DRG SUBMITTAL
G0.1
 Plotted On: 5/26/22

COVER SHEET

CABIN 9 EXISTING-DEMO & PROPOSED FIRST FLOOR PLAN

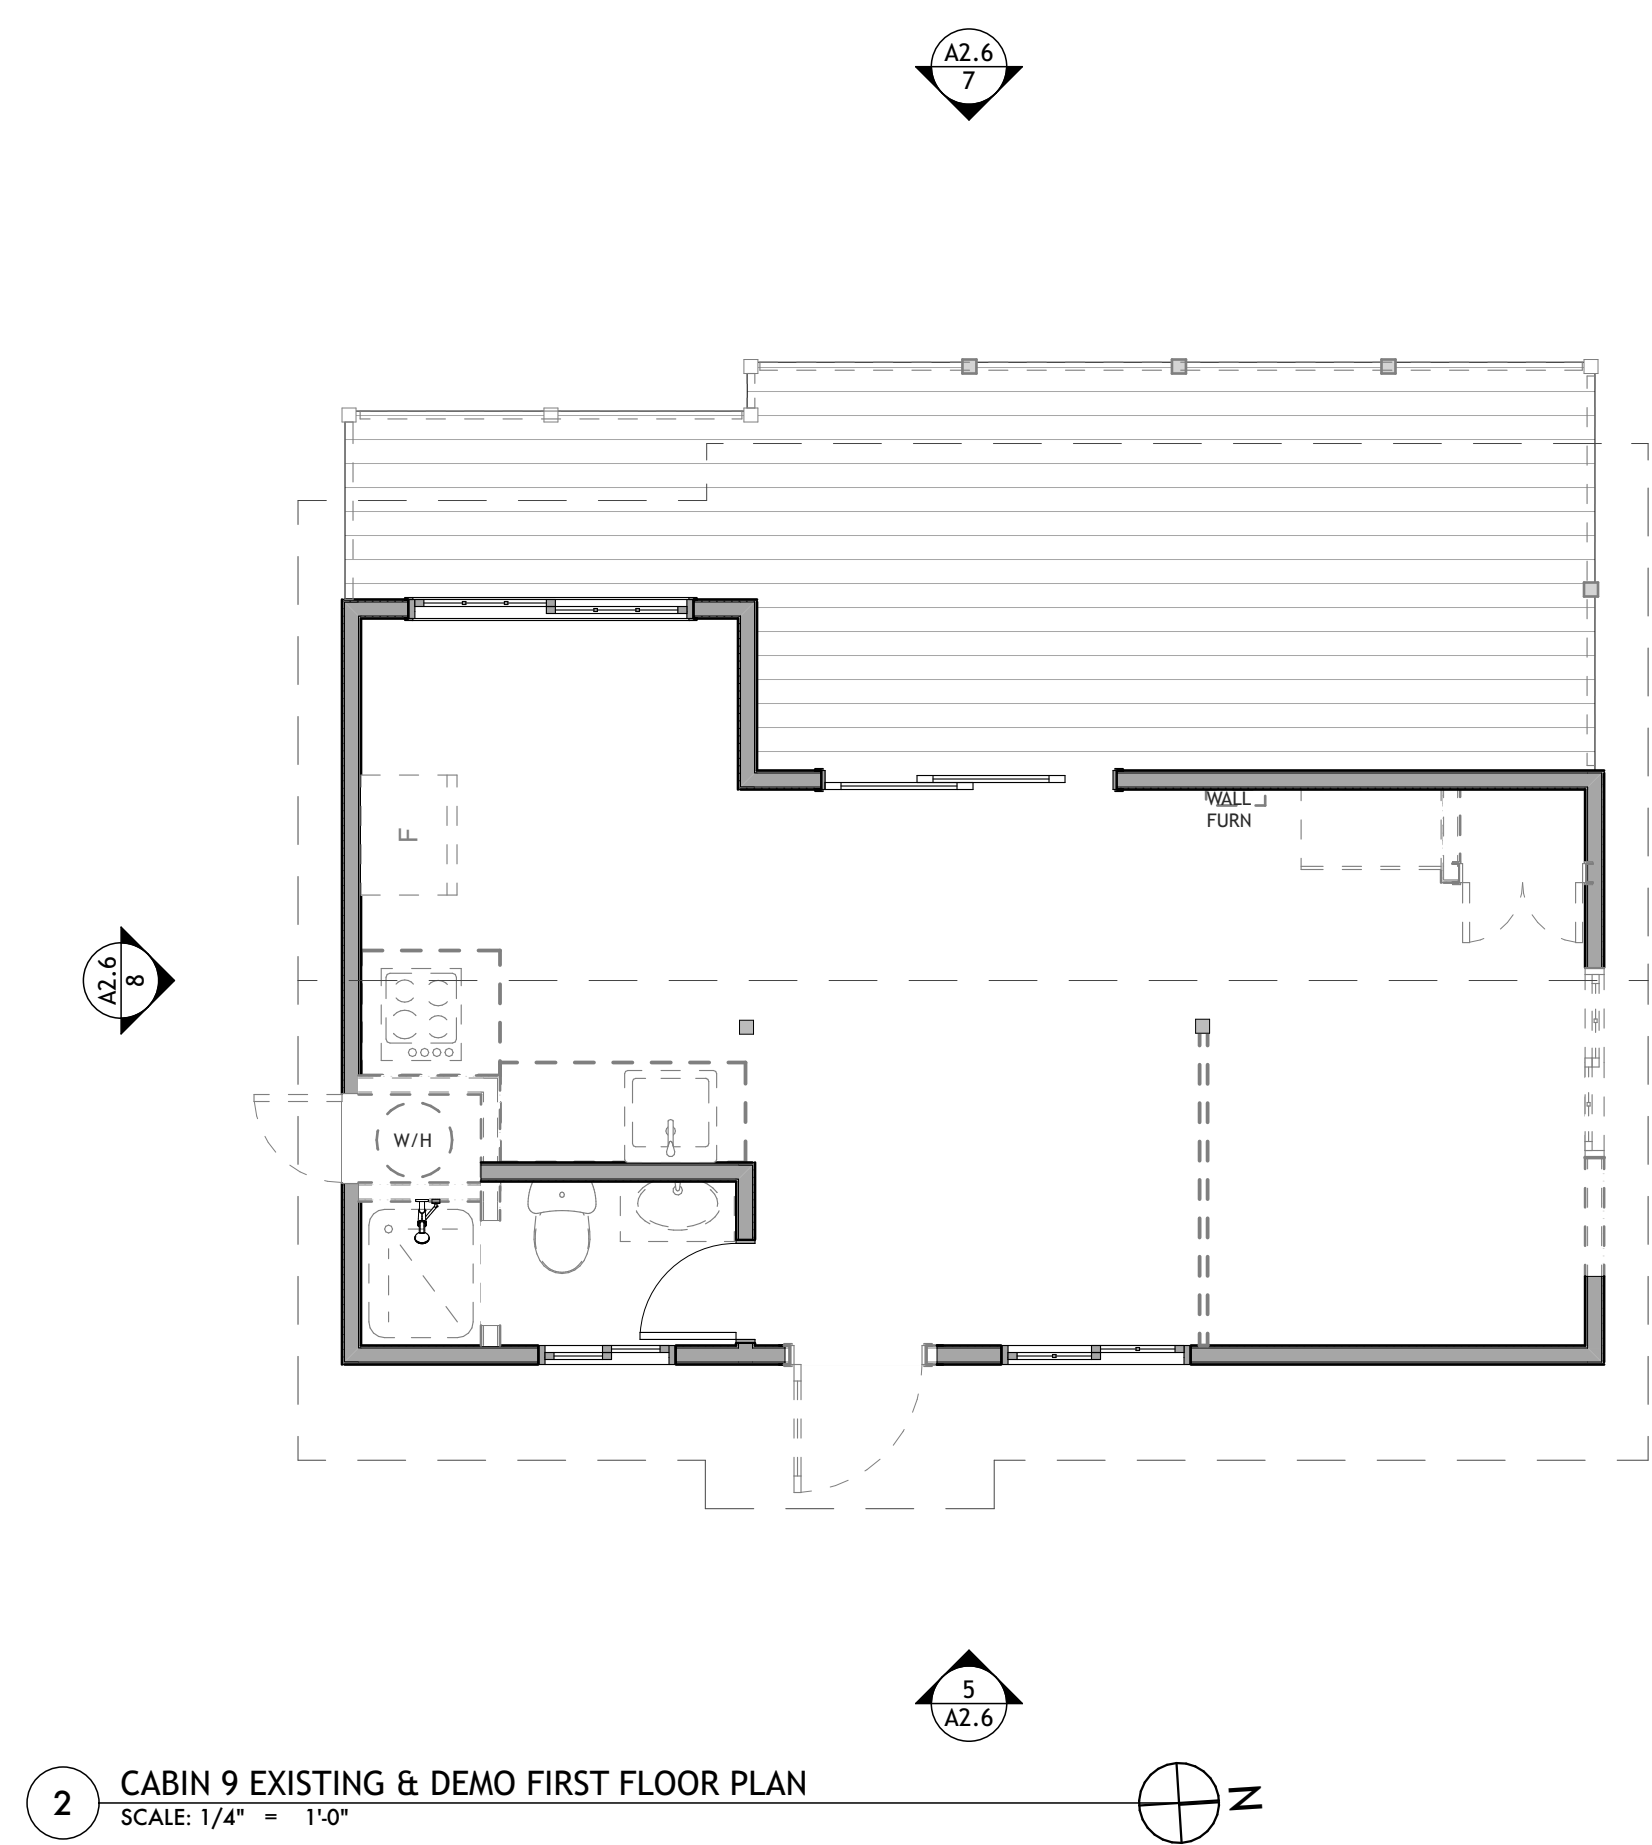
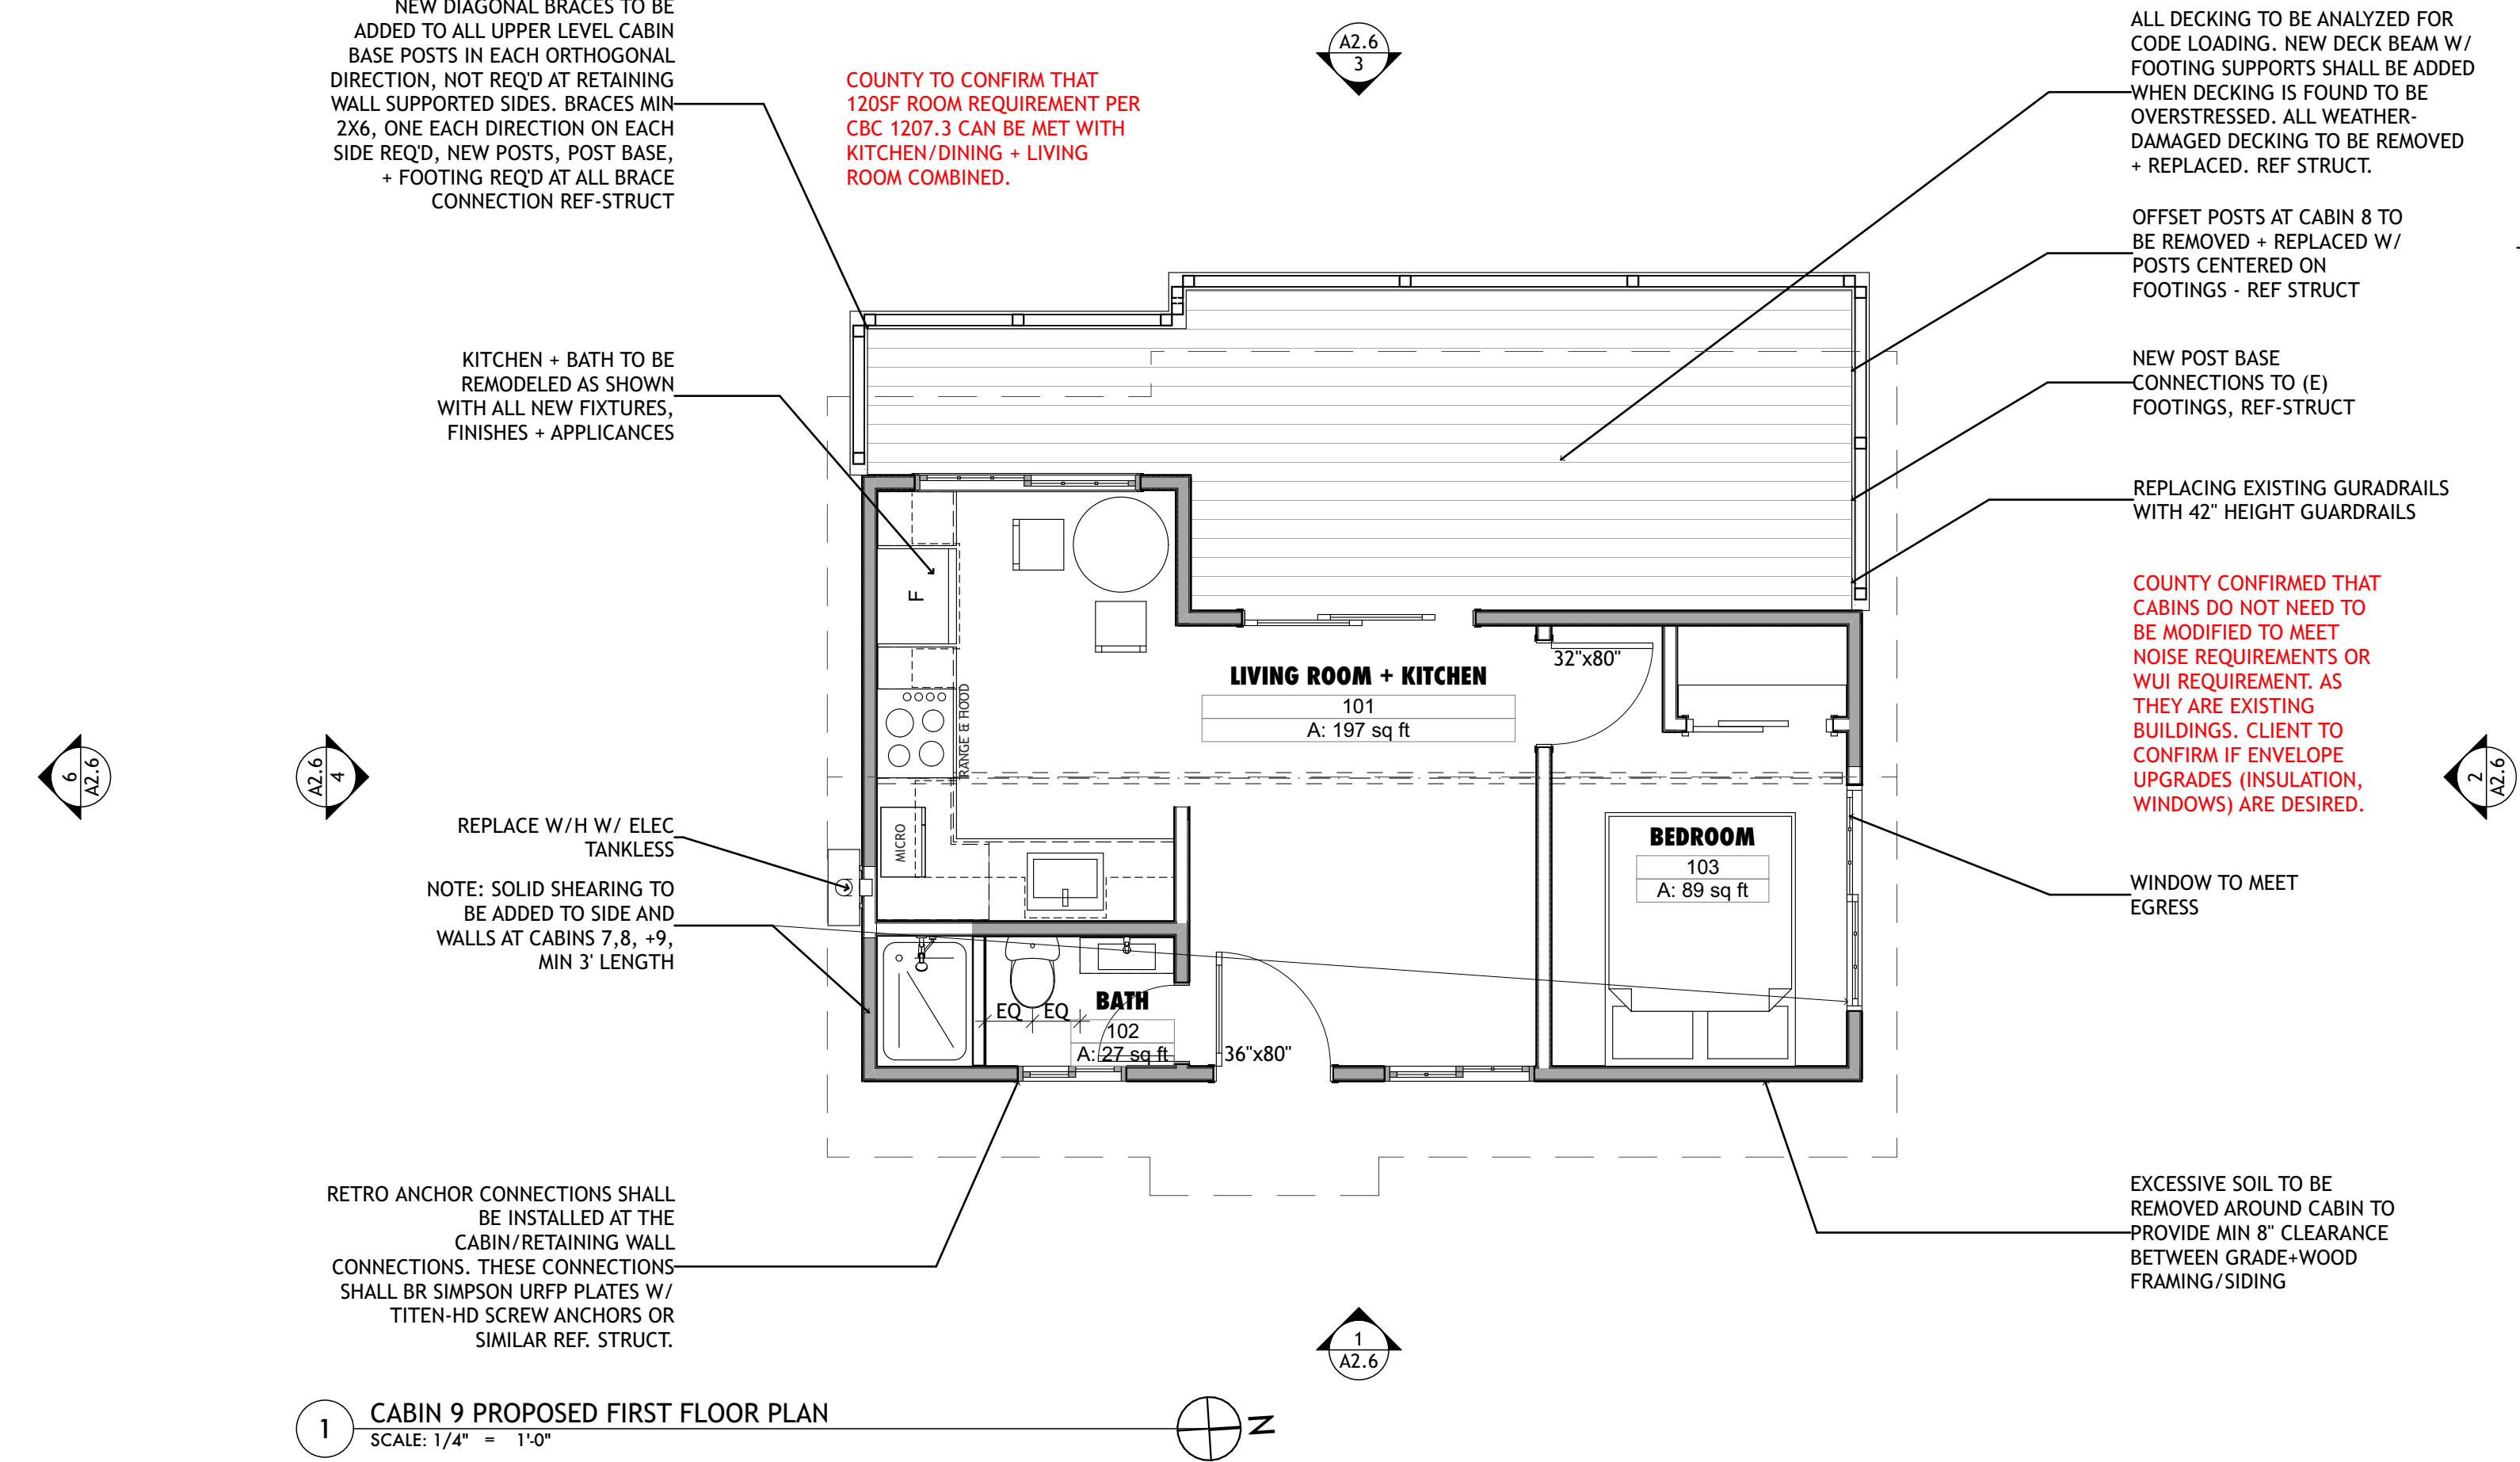
NEW DIAGONAL BRACES TO BE ADDED TO ALL UPPER LEVEL CABIN BASE POSTS IN EACH ORTHOGONAL DIRECTION, NOT REQD AT RETAINING WALL SUPPORTED SIDES. BRACES MIN 2X6, ONE EACH DIRECTION ON EACH SIDE REQD, NEW POSTS, POST BASE, + FOOTING REQD AT ALL BRACE CONNECTION REF-STRUCT

REPLACE W/H W/ ELEC TANKLESS
 NOTE: SOLID SHEARING TO BE ADDED TO SIDE AND WALLS AT CABINS 7, 8, +9, MIN 3' LENGTH

ALL DECKING TO BE ANALYZED FOR CODE LOADING. NEW DECK BEAM W/ FOOTING SUPPORTS SHALL BE ADDED WHEN DECKING IS FOUND TO BE OVERSTRESSED. ALL WEATHER-DAMAGED DECKING TO BE REMOVED + REPLACED. REF STRUCT.

COUNTY CONFIRMED THAT CABINS DO NOT NEED TO BE MODIFIED TO MEET NOISE REQUIREMENTS OR WUI REQUIREMENT, AS THEY ARE EXISTING BUILDINGS. CLIENT TO CONFIRM IF ENVELOPE UPGRADES (INSULATION, WINDOWS) ARE DESIRED.

EXCESSIVE SOIL TO BE REMOVED AROUND CABIN TO PROVIDE MIN 8" CLEARANCE BETWEEN GRADE-WOOD FRAMING/SIDING
